Denver Public Schools
Purchasing Department
1617 S. Acoma St.
Denver, Colorado 80223

**INVITATION TO BID 14-MC-2202
ADDENDUM NUMBER ONE
February 3, 2014**

**THIS ADDENDUM SHALL BECOME A PART OF THIS SOLICITATION.
Amend Invitation to Bid 14-MC-2202 as follows:**

R5 ROOF ASSEMBLY (ALTERNATE L.5):
07 5323 EPDM Roofing System with Tapered Insulation
1 1/2" = 1'-0"

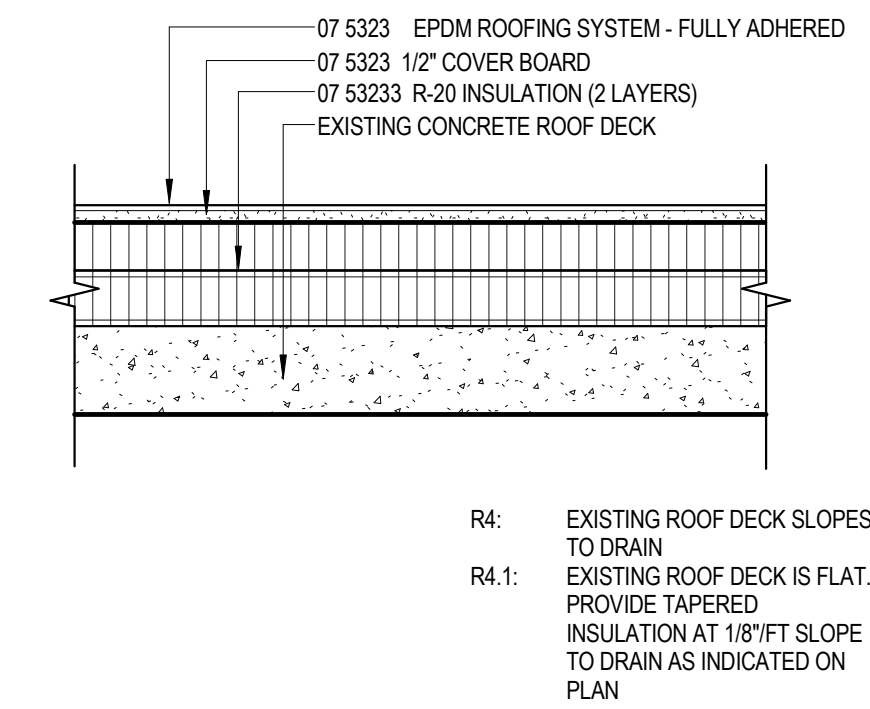
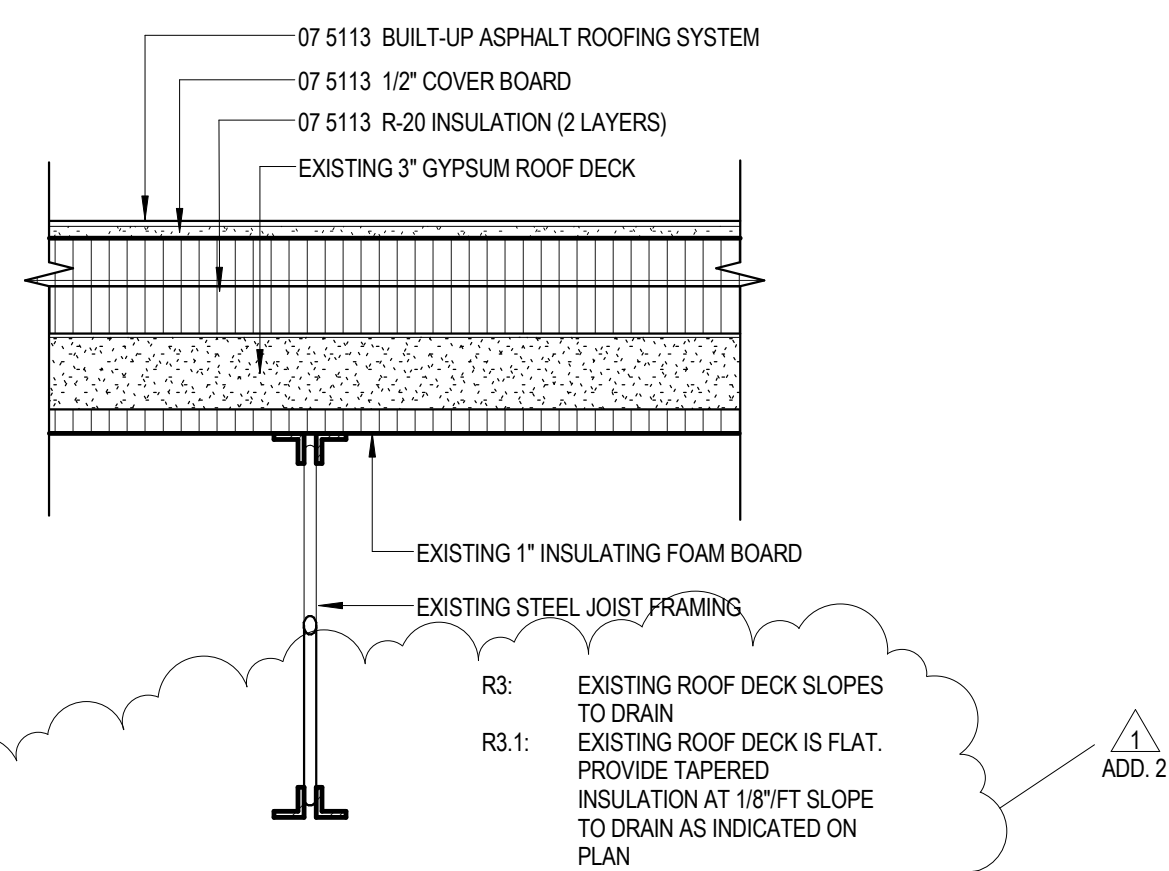
- A. Revise roof assembly R1 per attached drawing.
- B. Revise roof assembly titles for R2, R2.1, R3 and R3.1 per attached drawing.
- C. Add Alternate L.5 roof assemblies R4, R4.1 and R5 per attached drawing.

| NO. | DATE | DESCRIPTION OF REVISION | AUTHORITY | MADE | APPRVD |
|---|-----------------------|-------------------------|-------------------------|------------|------------|
| A-106L | | | | | |

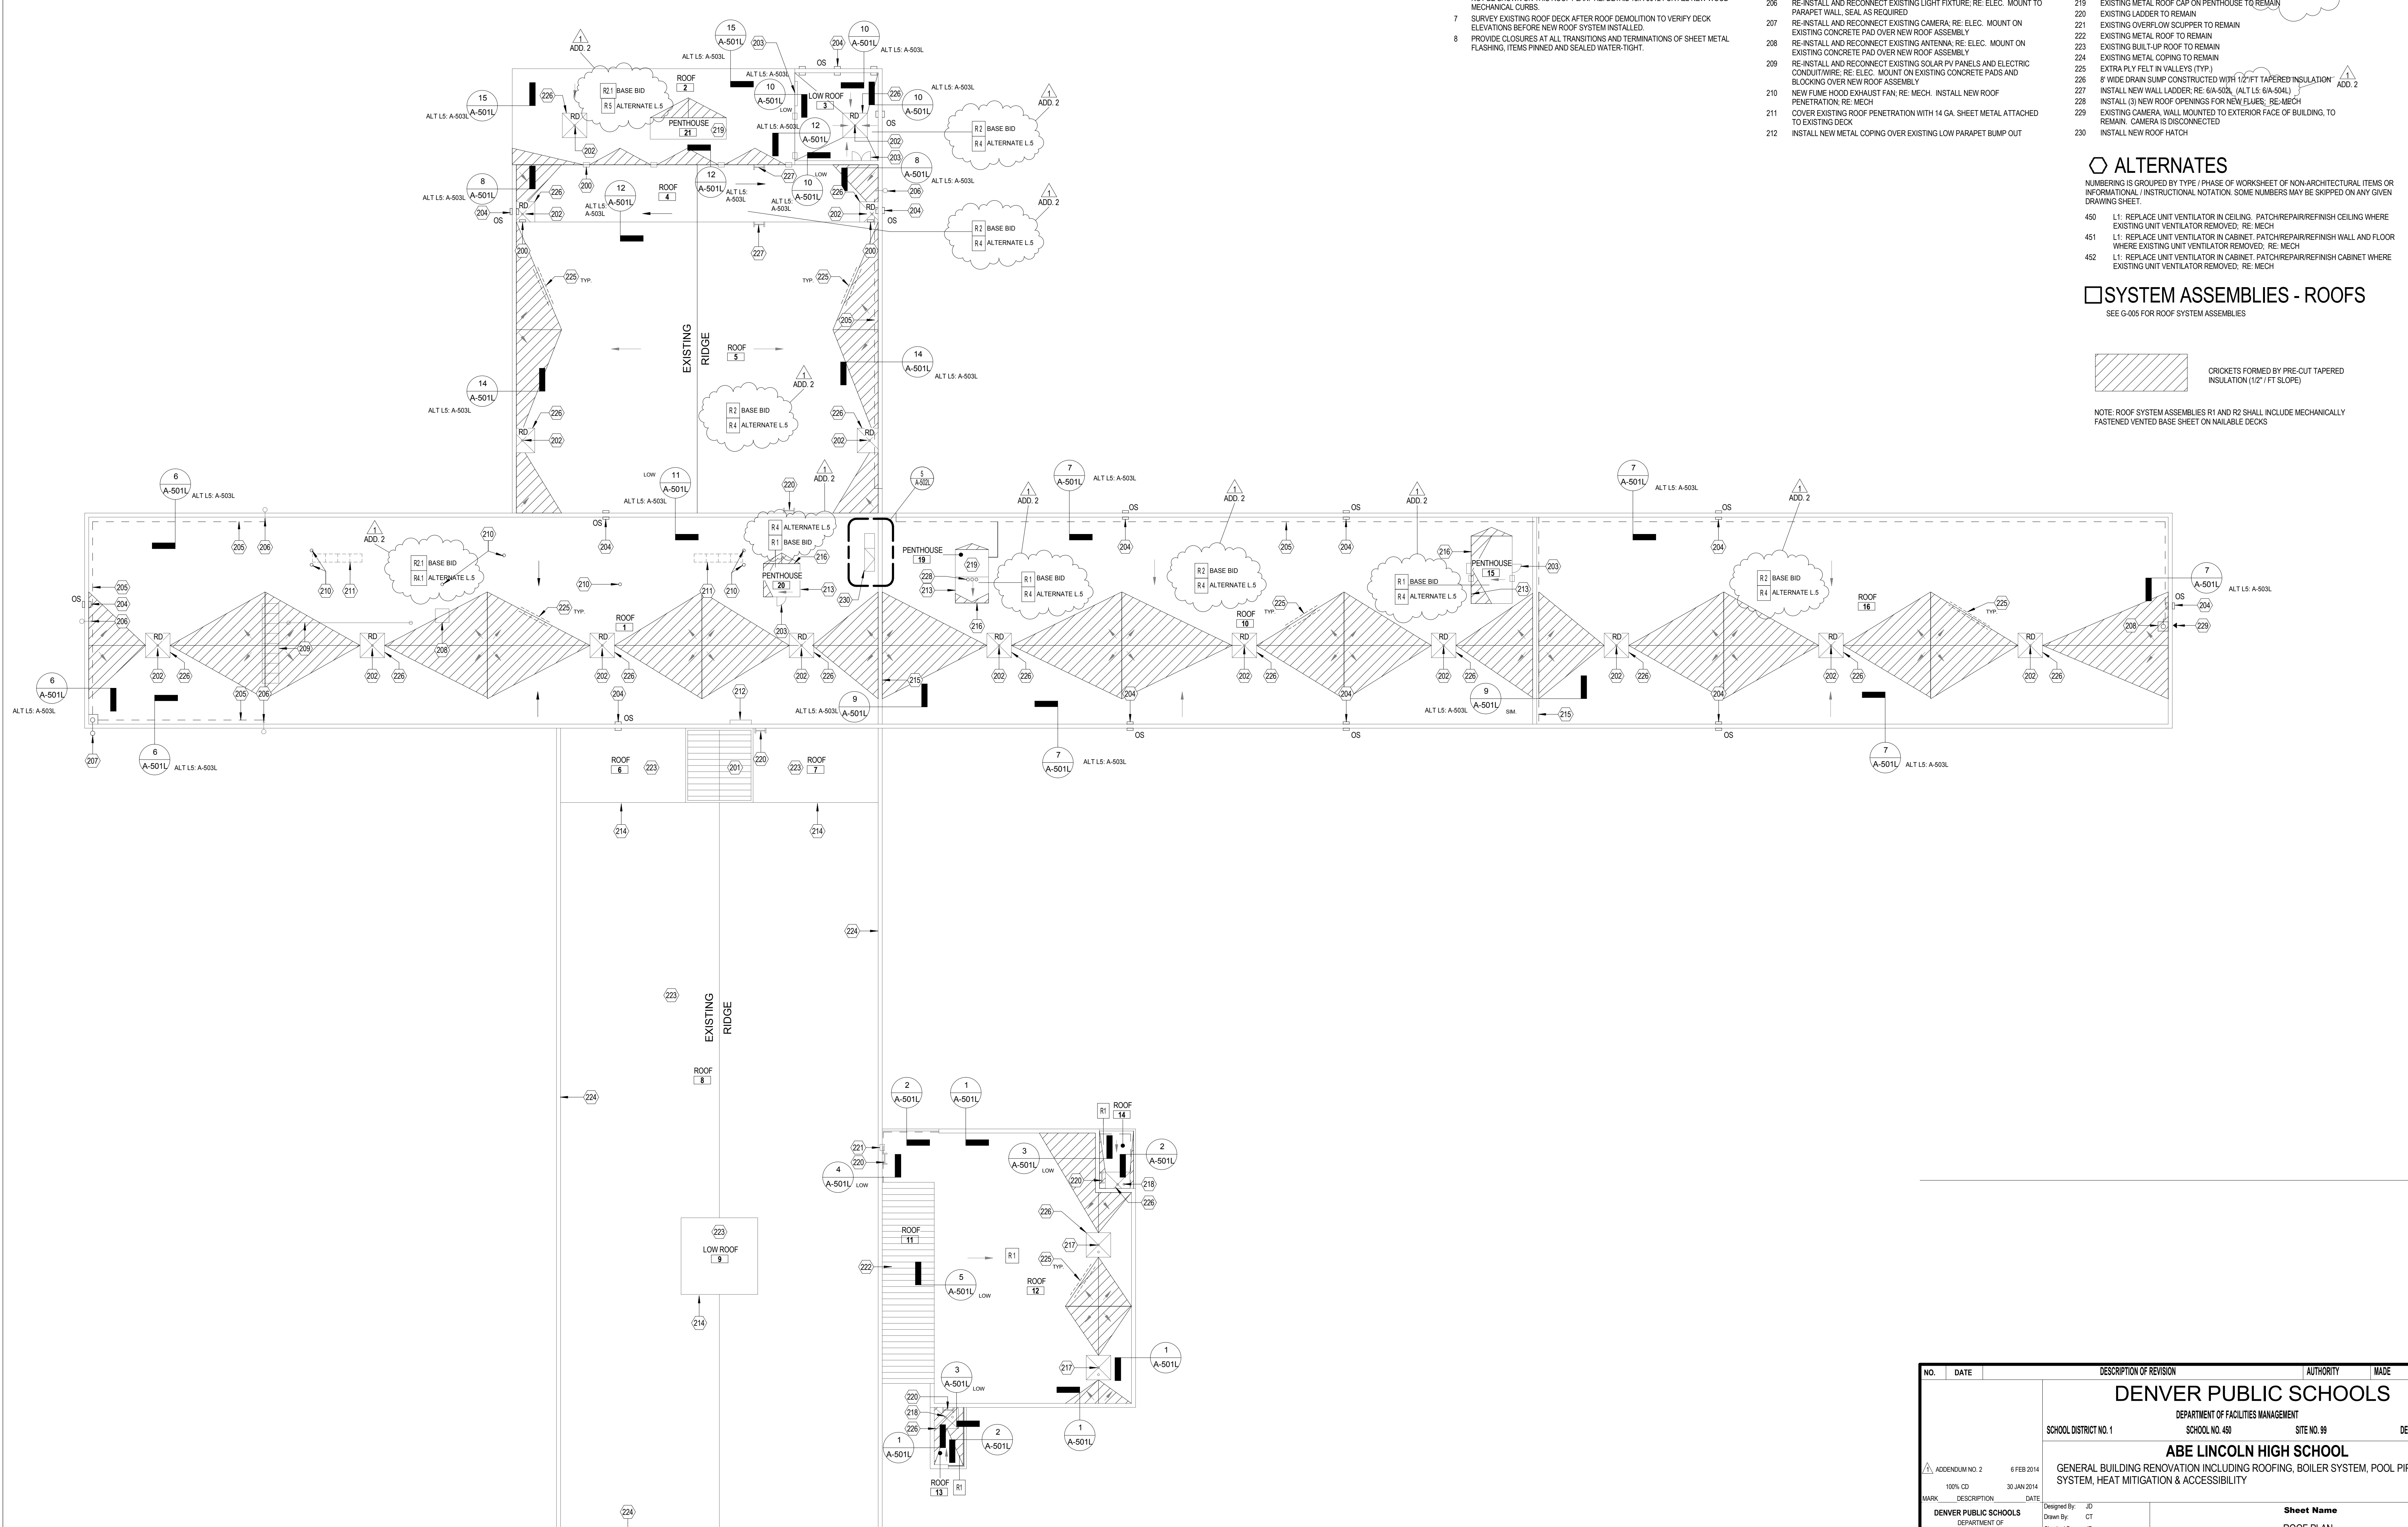
- 5.03 DRAWING A-106L:
 - A. Revise roof assembly tags to include Alternate L.5 per attached drawing.
- 5.04 DRAWING A-501L:
 - A. Revise sheet title to include "Base Bid" per attached drawing.
 - B. Revise detail 6 to delete "Existing Concrete Topping" note, per attached drawing.
- 5.05 DRAWING A-502L:
 - A. Revise sheet title to include "Base Bid" per attached drawing.
- 5.06 DRAWING A-503L:
 - A. Add new Roof Detail sheet for Alternate L.5, attached.
- 5.07 DRAWING A-504L:
 - A. Add new Roof Detail sheet for Alternate L.5, attached.
